SUBJECT: TECHNICAL SPECIFICATION AMENDMENT PERTAINING TO THE OPERATING
LIMIT MINIMUM CRITICAL POWER RATIO AND THE THERMAL-HYDRAULIC
STABILITY FOR PEACH BOTTOM, UNIT 3

PEACH BOTTOM ATOMIC POWER STATION, UNIT NO. 3

Amendment No. 107
License No. DPR-56

AMENDMENT NO. 107 TO FACILITY OPERATING LICENSE NO. DPR-56

FIGURE 3.5.K.2 MCPR OPERATING LIMIT vs τ

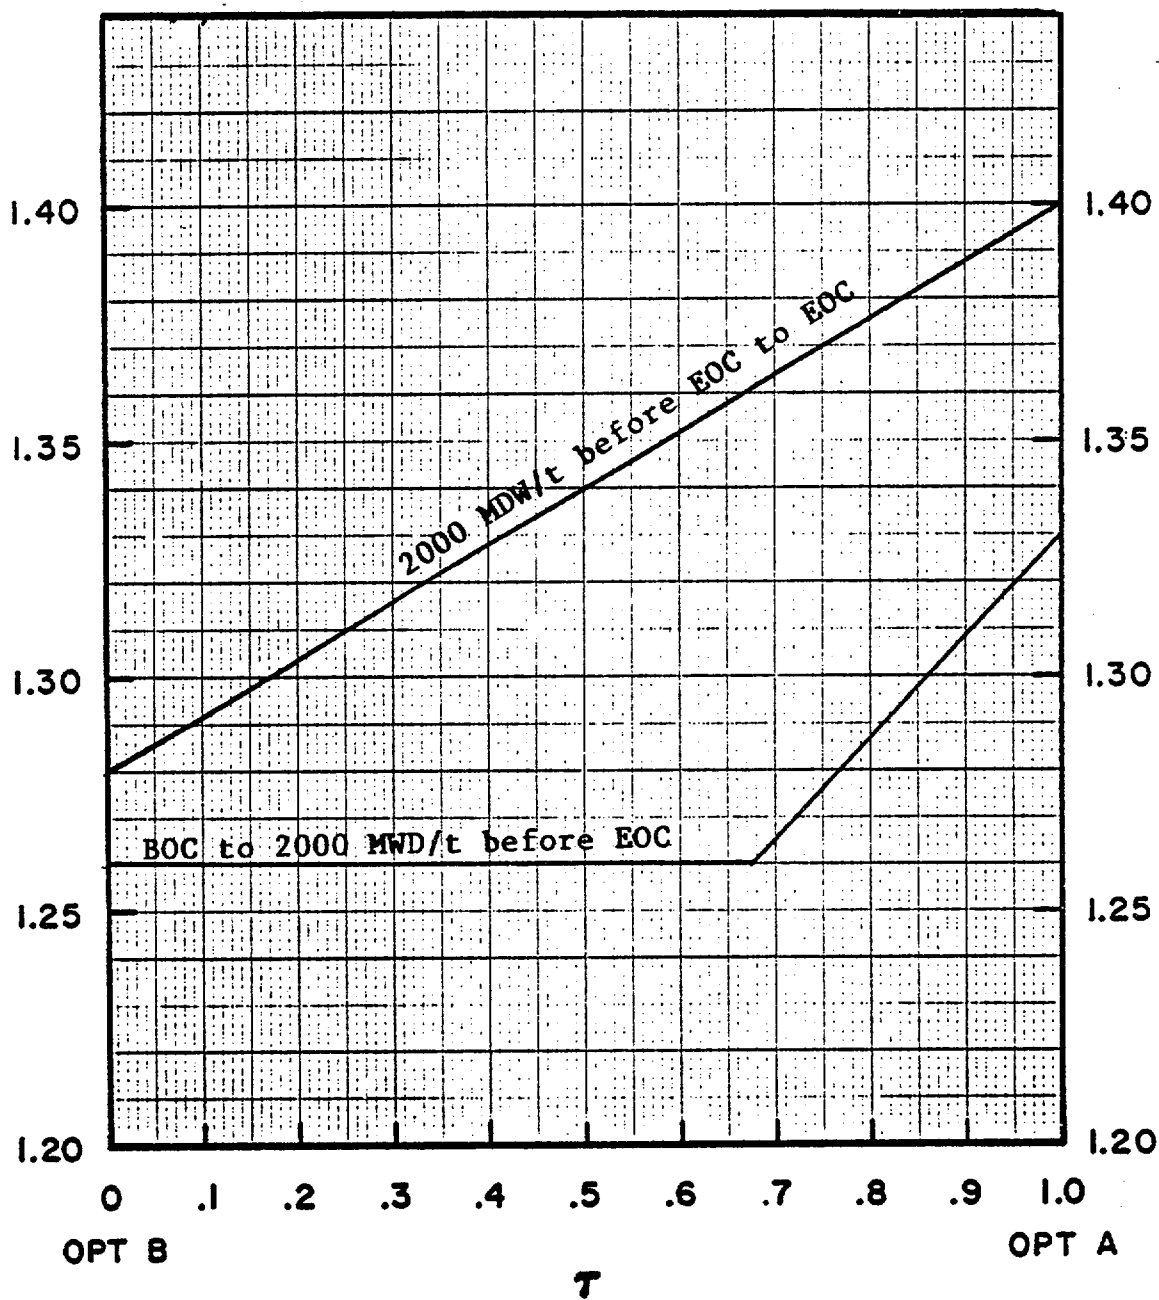
Table 3.5.K.2

<u>Fuel Type</u>	<u>MCPR Operating Limit For Incremental Cycle Core Average Exposure**</u>	
	BOC to 2000 MWD/t Before EOC	2000 MWD/t before EOC To EOC
PTA & PSX8R	1.26	1.28
LTA	1.26	1.28

** These values shall be increased by 0.01 for single loop operation.

FIGURE 3.6.5
THERMAL POWER AND CORE FLOW LIMITS OF
SPECIFICATIONS 3.6.F.3, 3.6.F.4, 3.6.F.5, 3.6.F.6 and 3.6.F.7

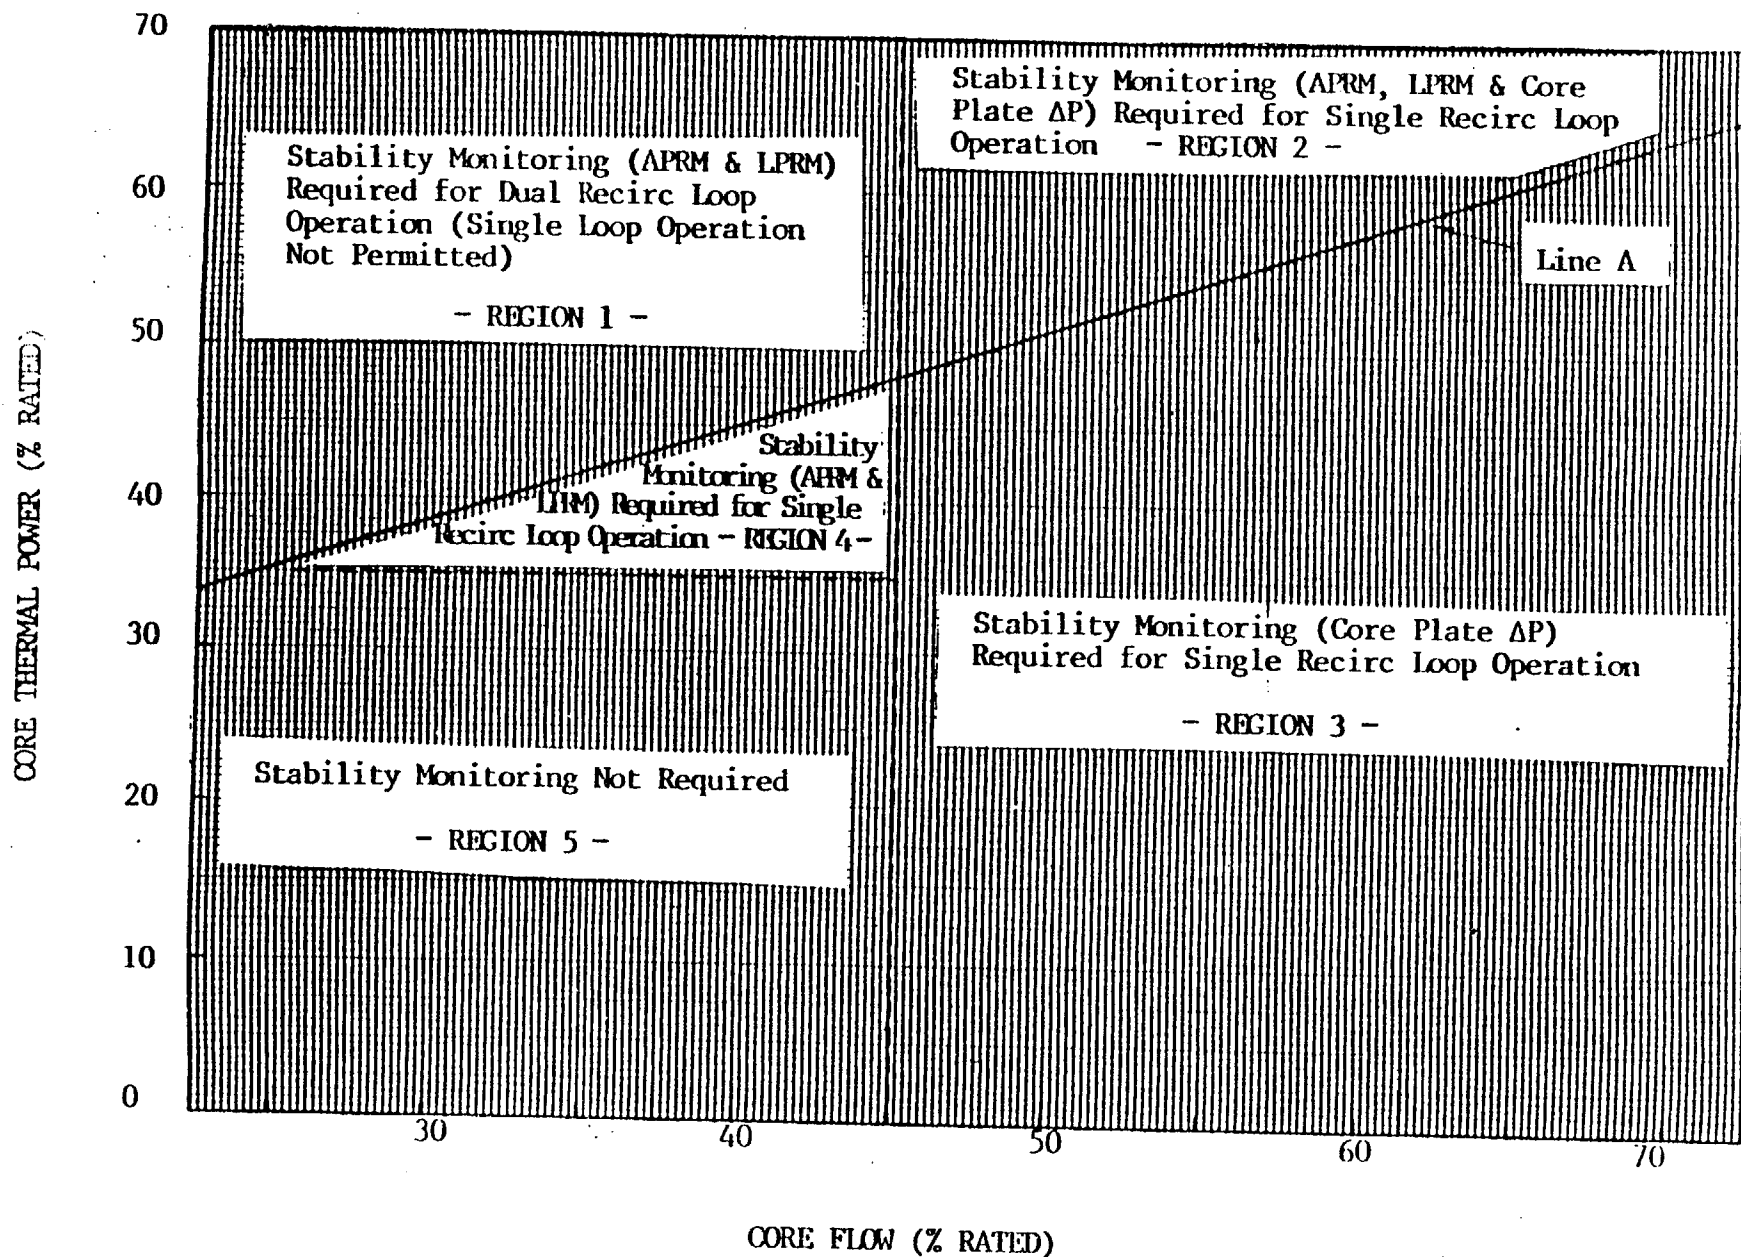
- a. Total core flow greater than or equal to 45% of rated core flow, or
 - b. Thermal Power less than or equal to the limit specified in Figure 3.6.5 (Line A).

4. With only one reactor coolant system recirculation loop operating, immediately initiate action to reduce thermal power and be below the limit specified in Figure 3.6.5 (Line A) or increase core flow to greater than or equal to 45% of rated core flow.

6. With two reactor coolant system recirculation loops in operation and total core flow less than 45% of rated core flow and Thermal Power greater than the limit specified in Figure 3.6.5 (Line A) (Region 1), or with only one reactor coolant system recirculation loop operating and the Thermal Power greater than the limit specified in Figure 3.6.5 (Line A) (Regions 1 or 2) or total core flow less than 45% of rated core flow with Thermal Power greater than 35% of Rated Thermal Power (Regions 1 or 4):

7. With one reactor coolant system recirculation loop in operation and total core flow greater than 45% of rated core flow (Regions 2 or 3):

b. With the core plate differential pressure noise level greater than 1 psi and 1.5 times the established baseline noise level, immediately initiate corrective action to restore the noise level to within the required limits within 2 hours or reduce core flow to less than 45% of rated core flow.
